ADDENDUM NO. 2

To: All prospective Bidders
DCR Contract #P24-3541-C1A
Lowe's Pond Dam Rehabilitation

Date: October 17, 2024

PROJECT
MASS DCR
ABANDONED DAMS
LOWES POND DAM
CONTRACT NO.
P19-3264-D4A

SHEET NUMBER
99 C-509

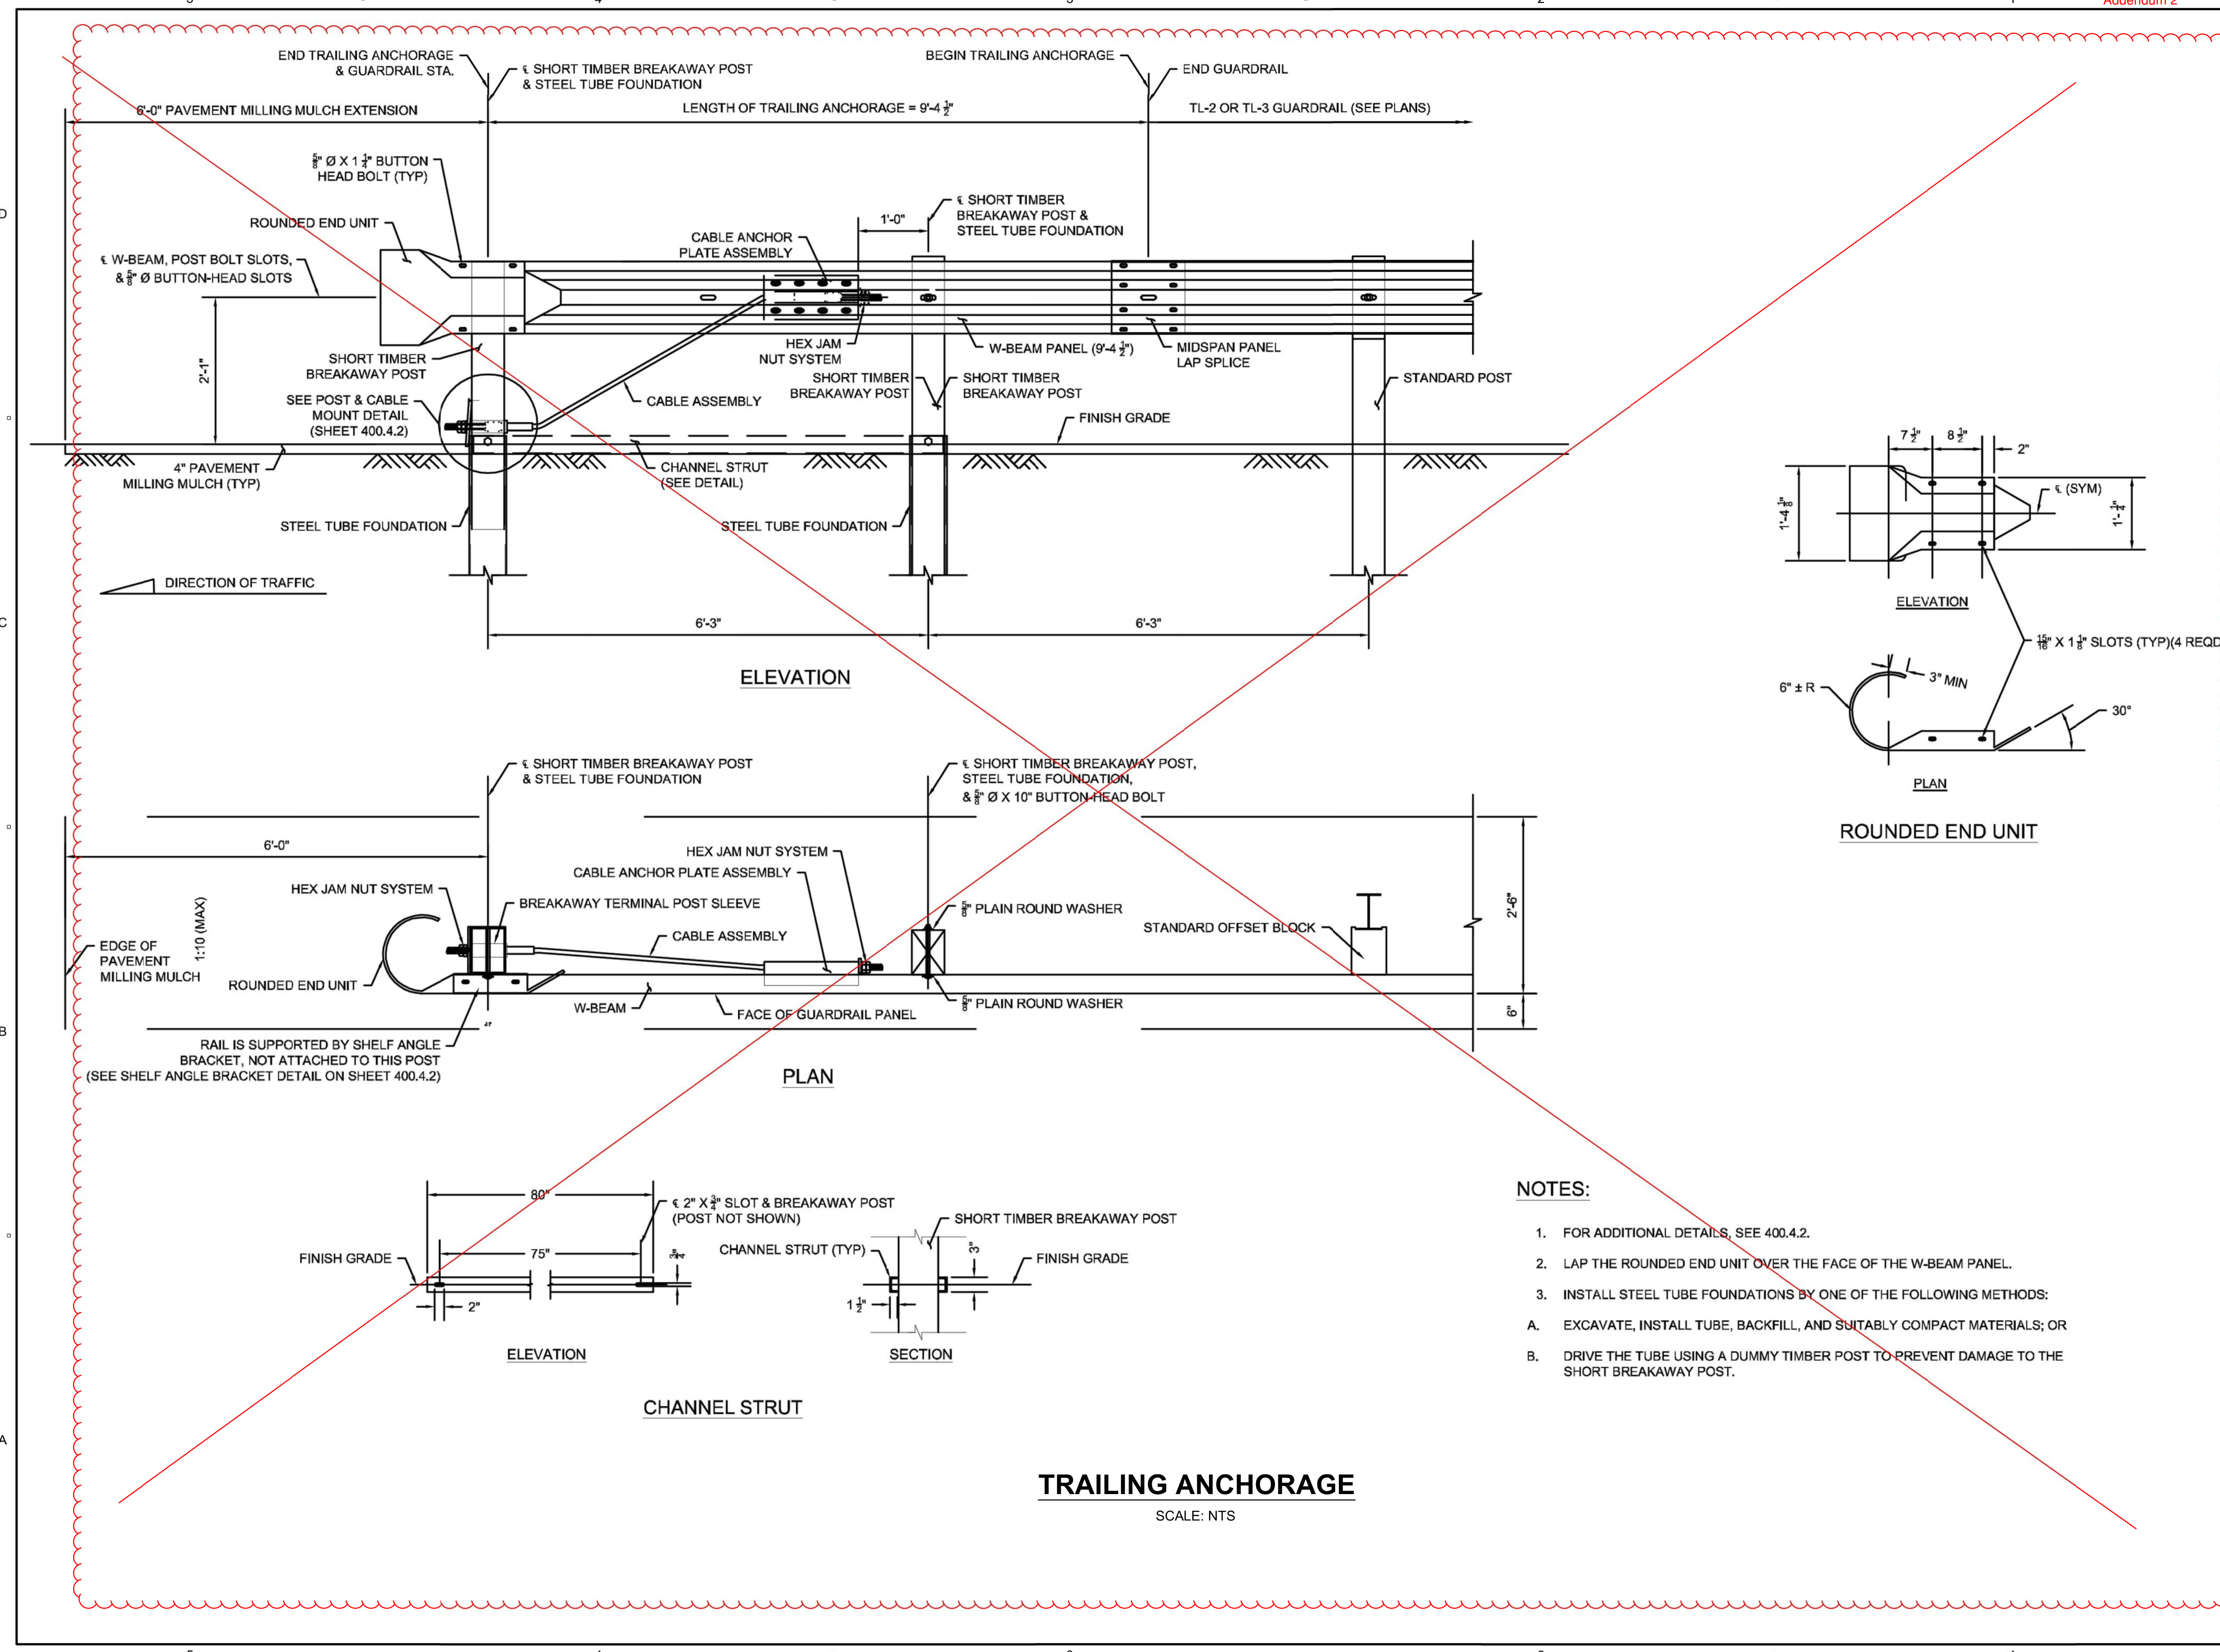
24. End terminal details on sheets 99 c-508, 99 c-509 show terminals that are compatible to a W-beam guardrail system. Proposed guardrail is steel backed timber guardrail . These are 2 totally different systems – please clarify. Due to the type of guardrail installation on this project end terminals are not warranted. Low speed traffic and parking spaces. please confirm.

revised with this addendum. This addendum is removing sheets C-506, C-508, C-509 and C-510 to eliminate contradiction.

AECOM Response: End terminals are not warranted.

SHEET NUMBER
99 C-510

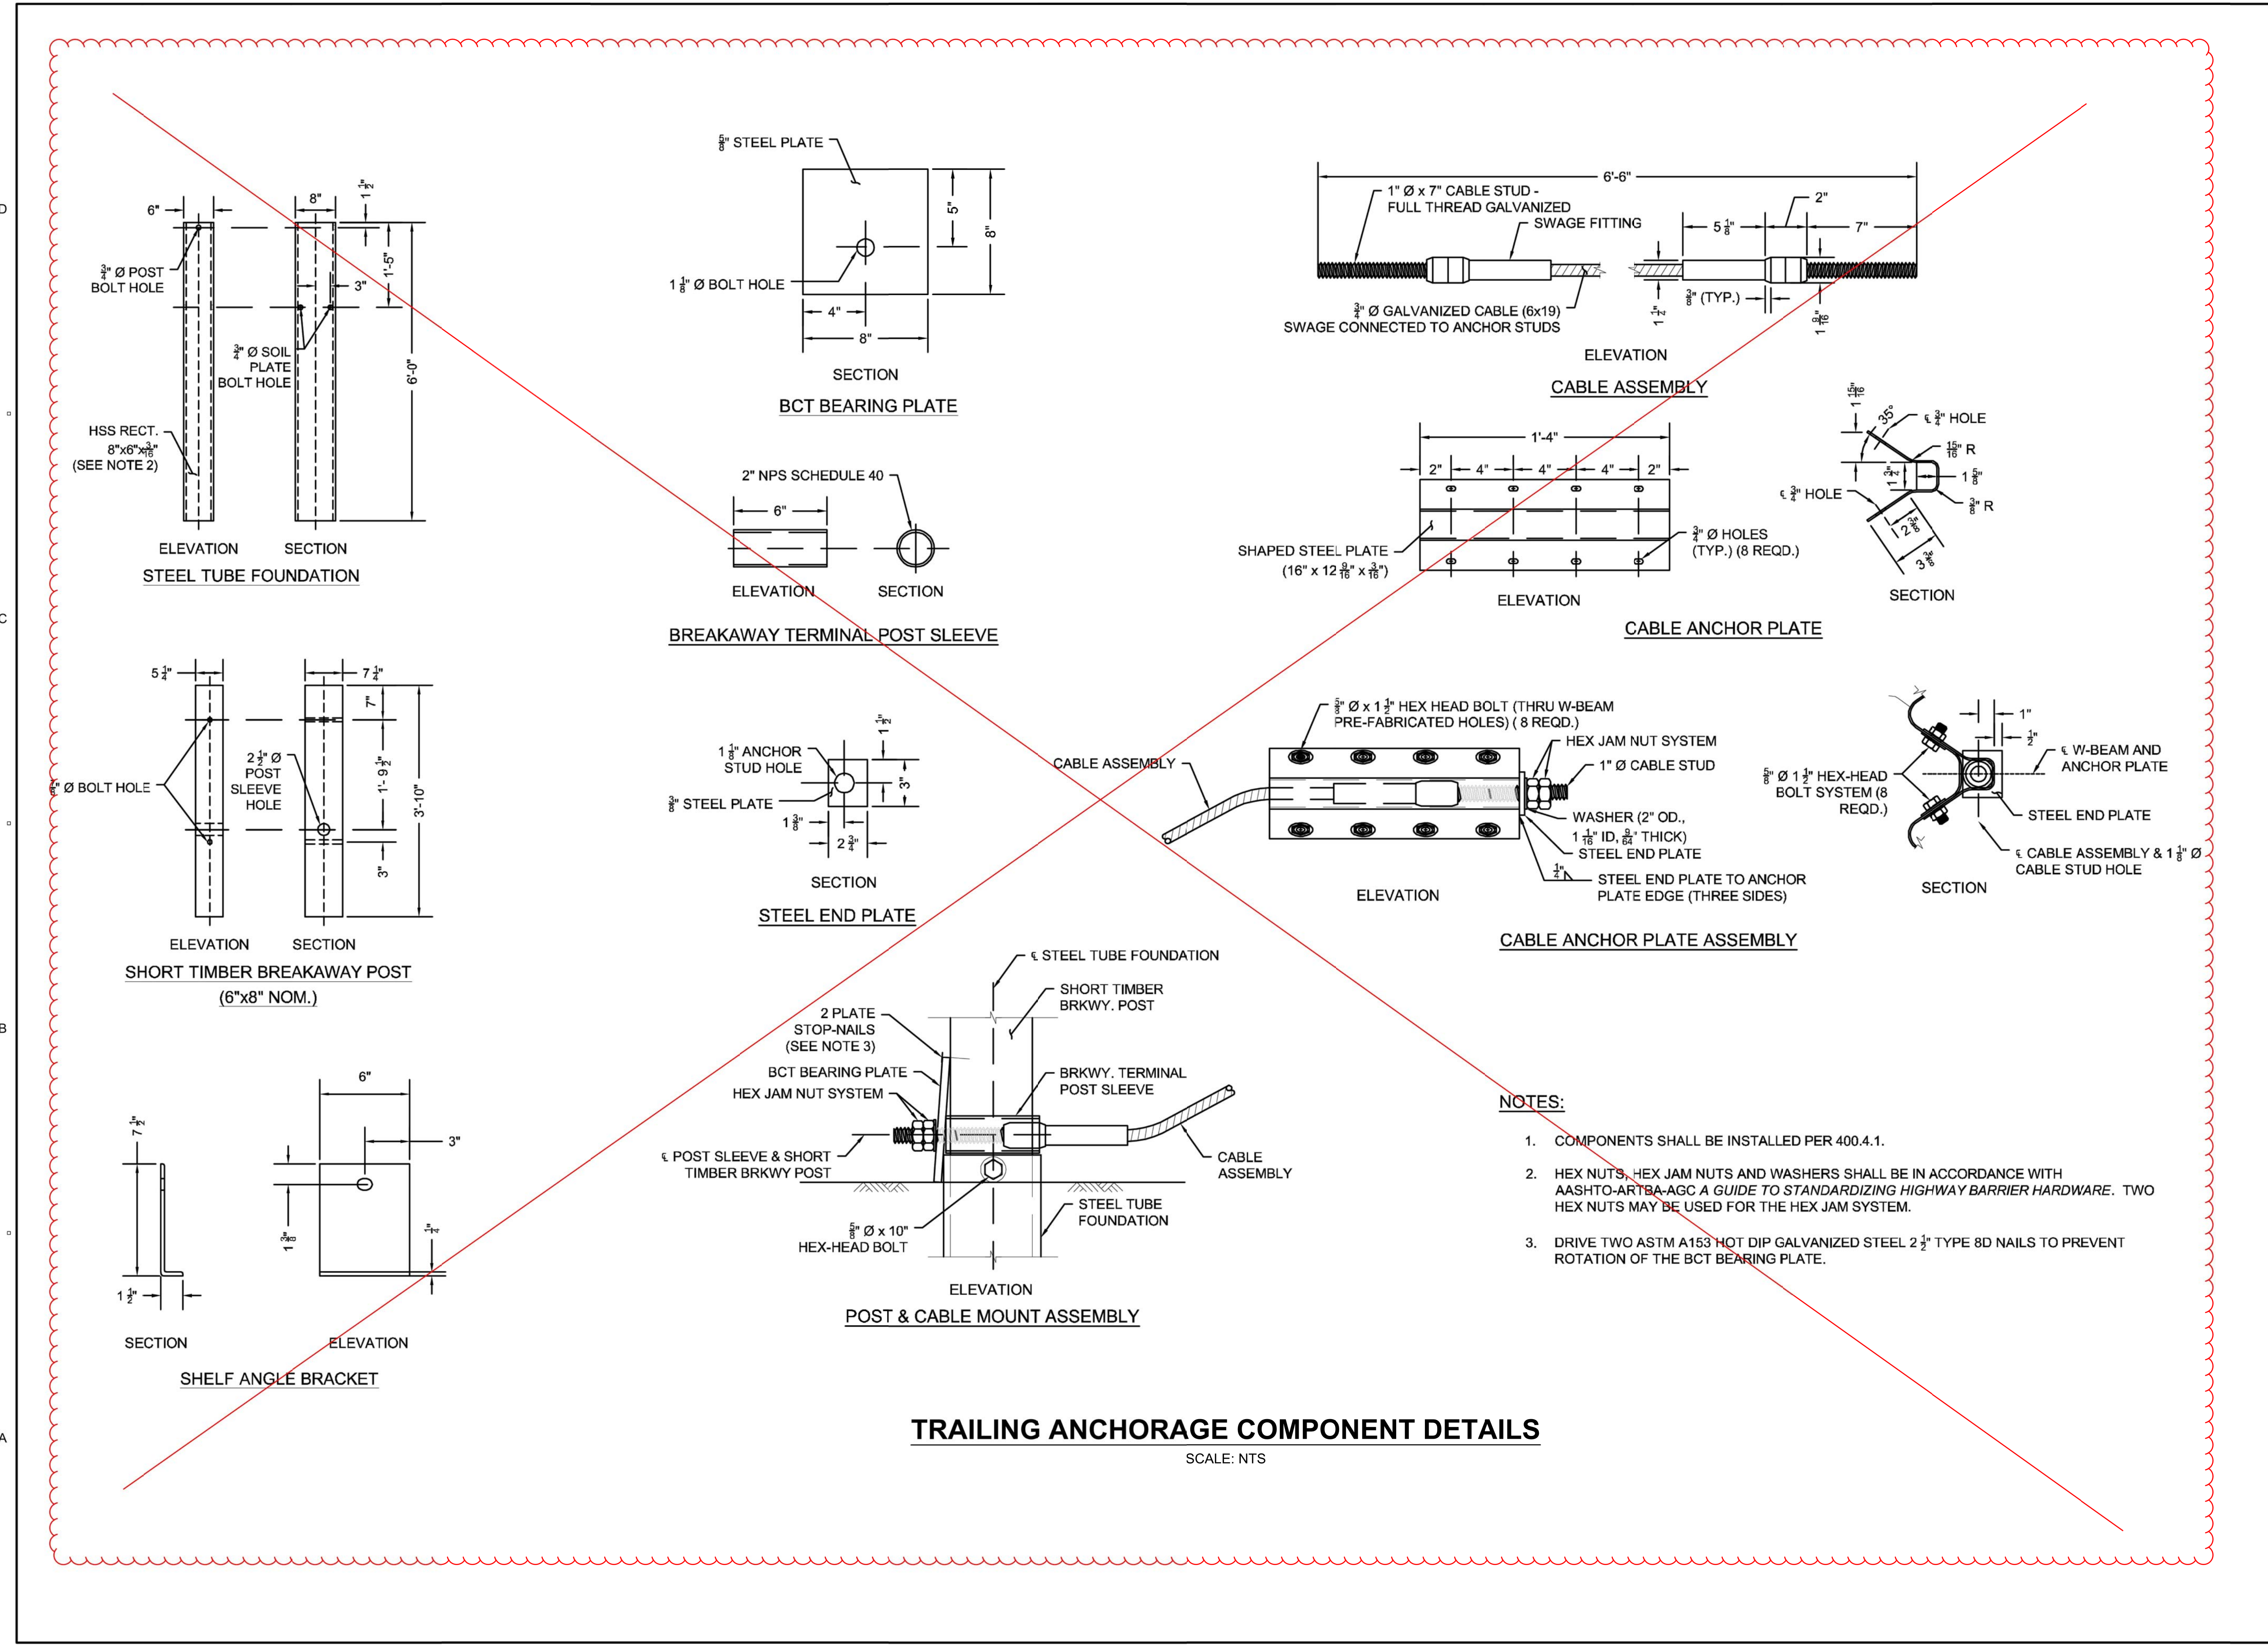
Sheet Numbers C-506, C-508, C-509 and C-510 have been removed
